Pierce Township Board of Zoning Appeals Hearings  
950 Locust Corner Road  
March 27<sup>th</sup>, 2024  
5:00 pm  
**Agenda**

**Pierce Township  
Board of Zoning Appeals  
March 27, 2024  
Case Number: BZA2024-001**

## **Dimensional Variance: 763 Old Locust Hill Road (272814D033.)**

Pierce Township  
Board of Zoning Appeals  
March 27, 2024  
Case Number: BZA2024-002

SHEET NUMBER:	A1.1
---------------	------

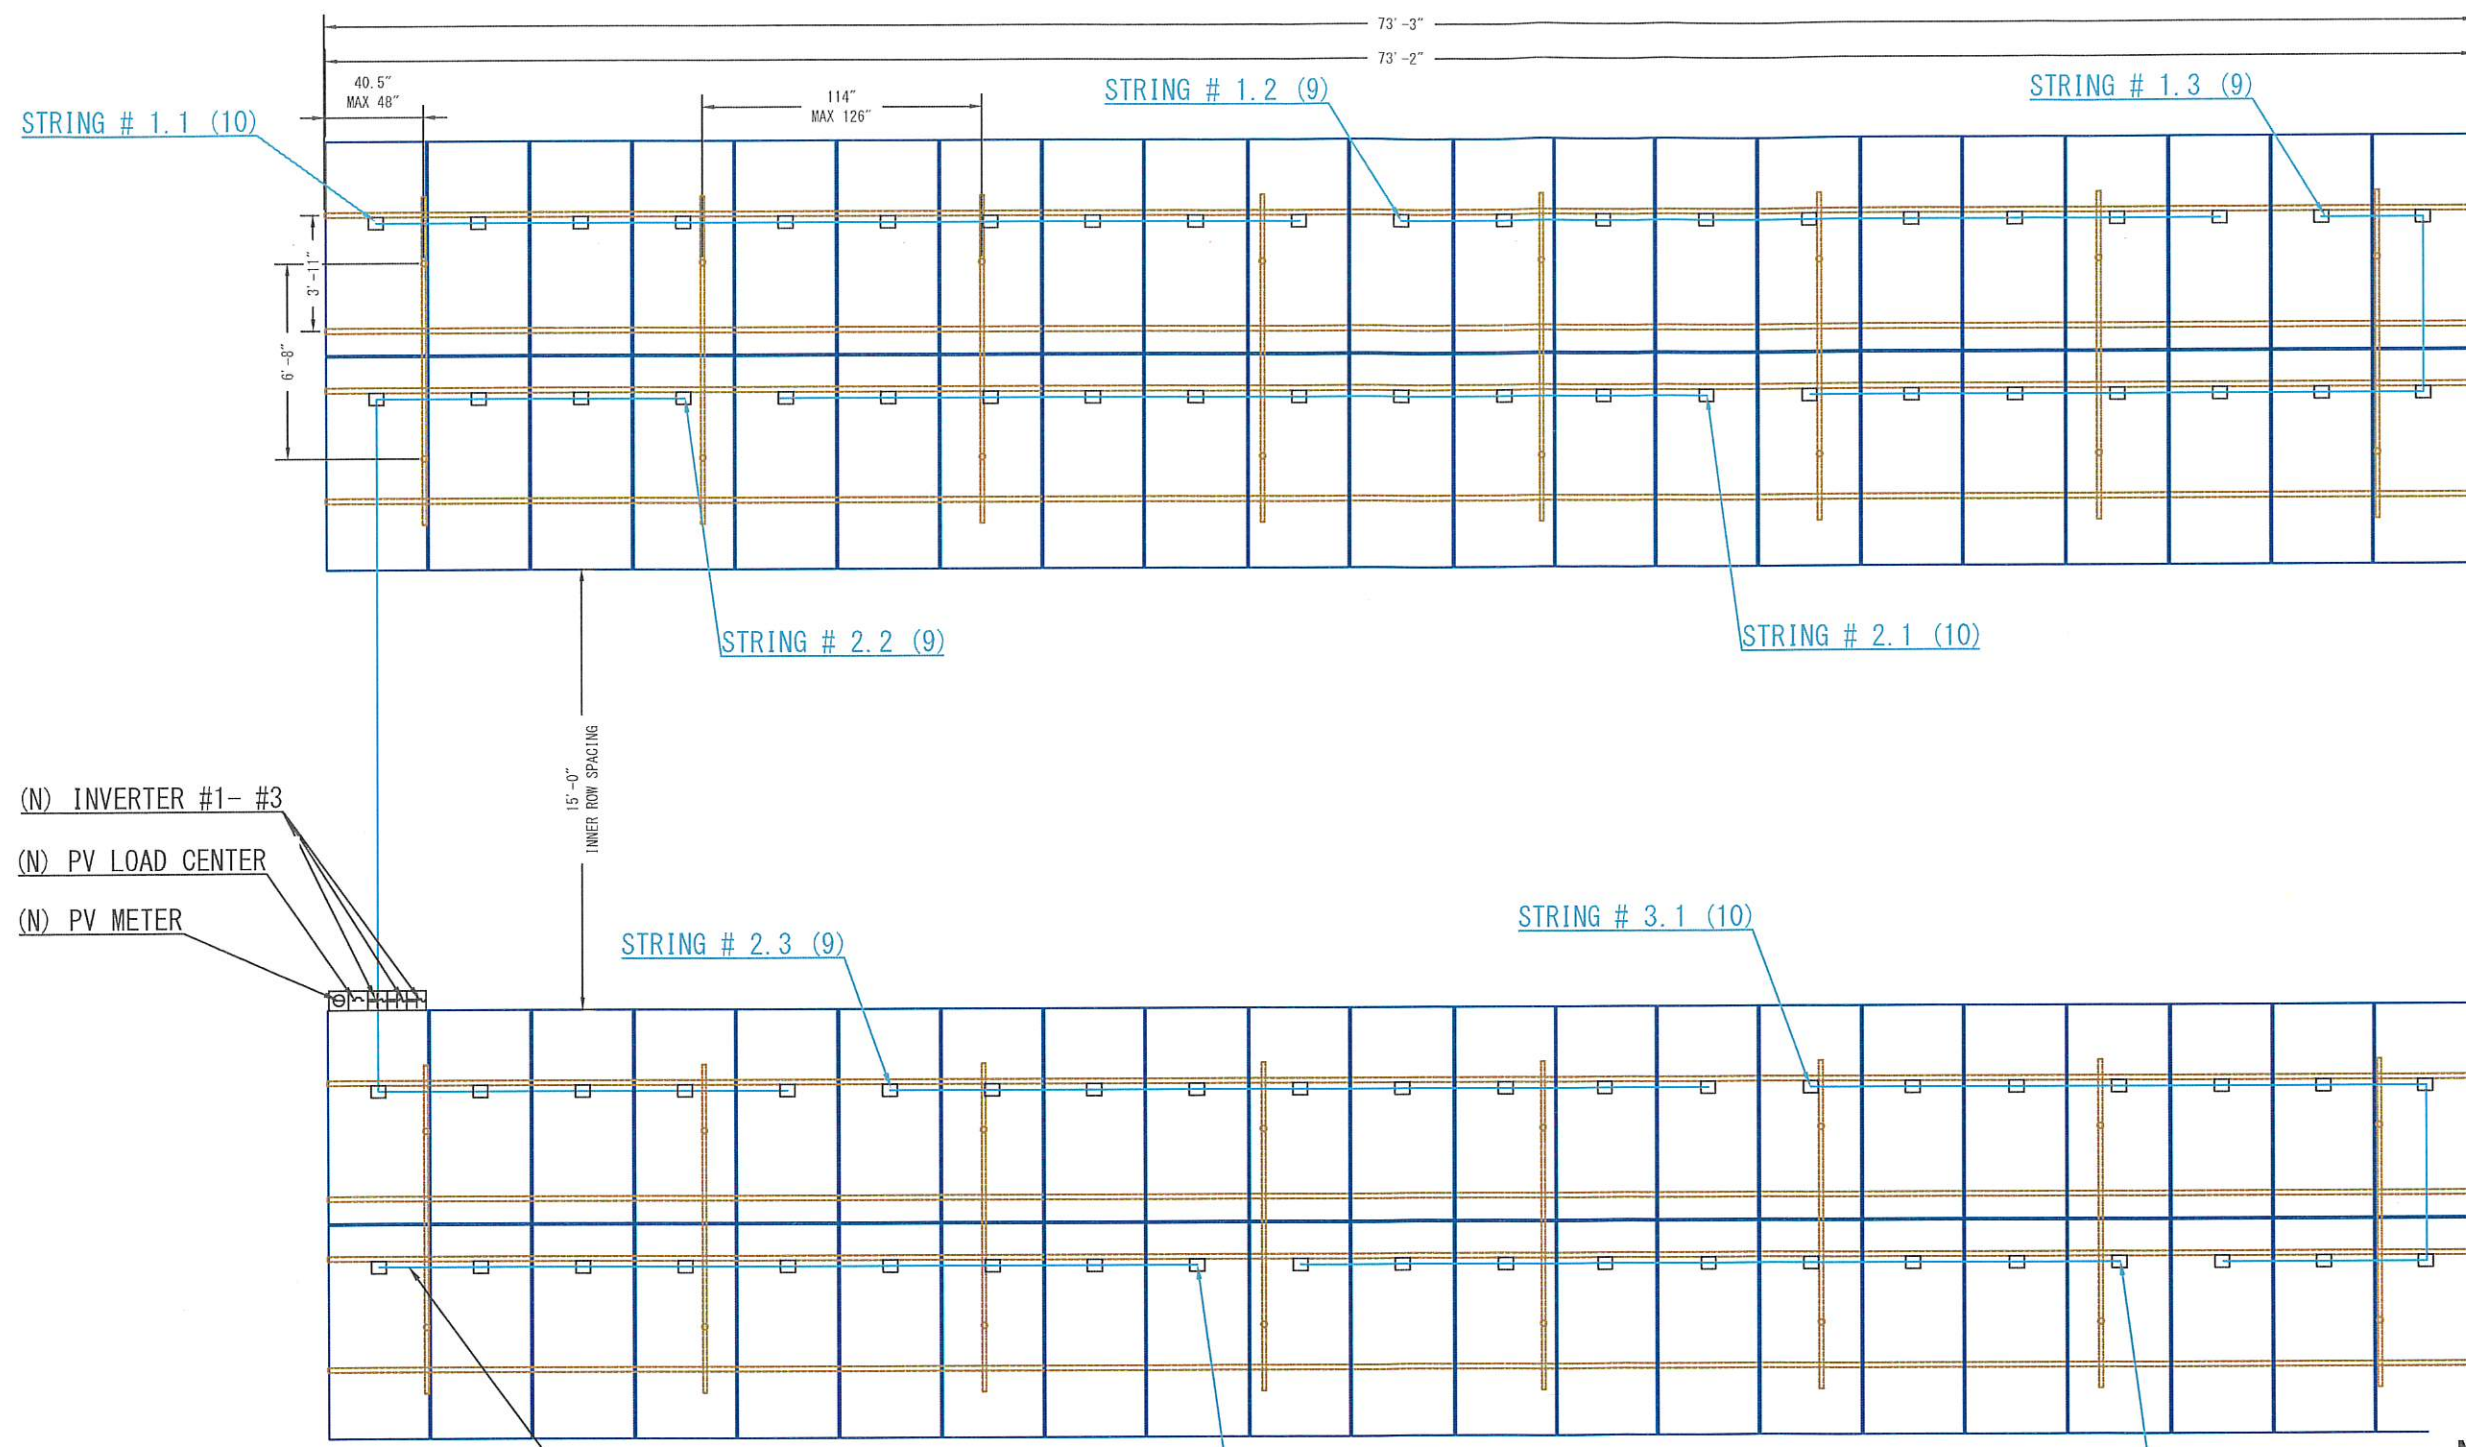
1. *Conflict 4.06(F)(12):* Solar panels are permitted only when placed on the roof of a structure. The proposed panels are ground mounted

*Staff Comment:* Evergreen and canopy tree plantings along the northern and western viewsheds of the proposal would mitigate visibility from 741 and 729 Old Locust Hill Road, should those properties develop in the future, while ensuring the southern facing arrays remain functional.

**Staff Comment:** *Character does not appear to be adversely affected at this time but may in the future due to the siting location near the right of way. Evergreen and canopy tree plantings along the northern and western viewsheds of the proposal would mitigate visibility from 741 and 729 Old Locust Hill Road, should those properties develop in the future, while ensuring the southern facing arrays remain functional.*

1. The subject lot must be combined with the parcel on which the dwelling is sited.
2. An approval letter from the Homeowner's Association
3. Evergreen and canopy tree plantings along the northern and western viewsheds of the proposal
4. The applicant must comply with all federal, state and local regulations.

**Proposed Detached Garage Site Plan:**

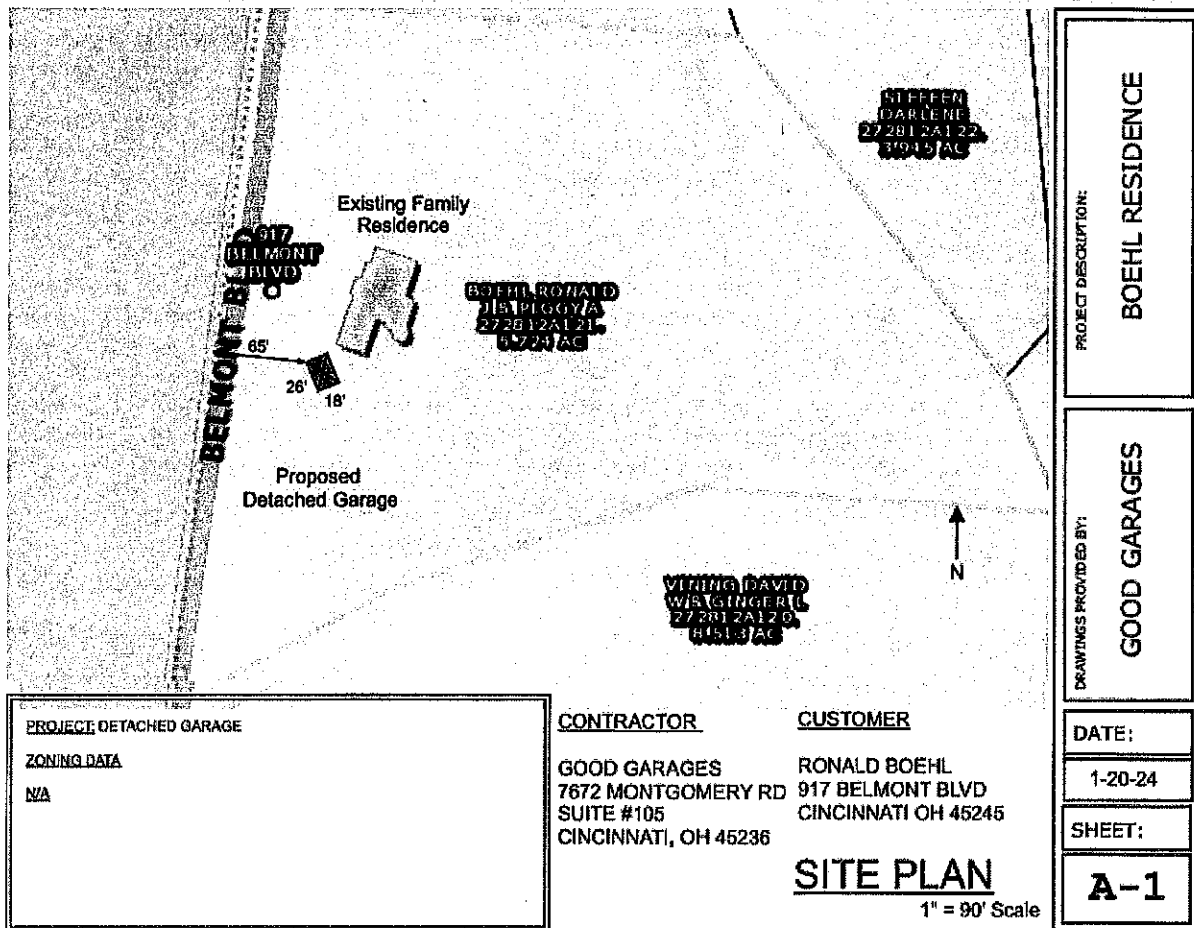
Thank you for providing your request to build a detached garage. According to the Site Plan, attached, the garage would be located to the west of your house. Also, a part of the garage will be in front of your house.

Because the other four properties located on Belmont Blvd all have garages which are in front of the house, and because Belmont Blvd is a private lane, we do not have any objection to your plans.

**Existing:**

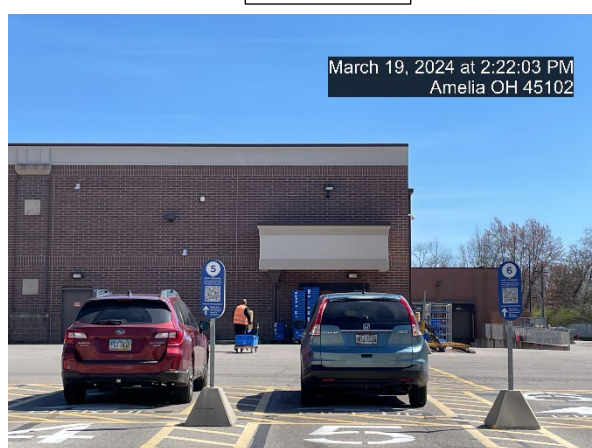
*Staff Comment: The 2023 request for an 80 sq. ft (stating “Pharmacy Drive Thru) was denied. The prior drive thru sign “Rx Drive-thru” (approved via variance in 2011) was 57.75 sq.ft, approx. 22.25 sq. ft smaller in area”.*
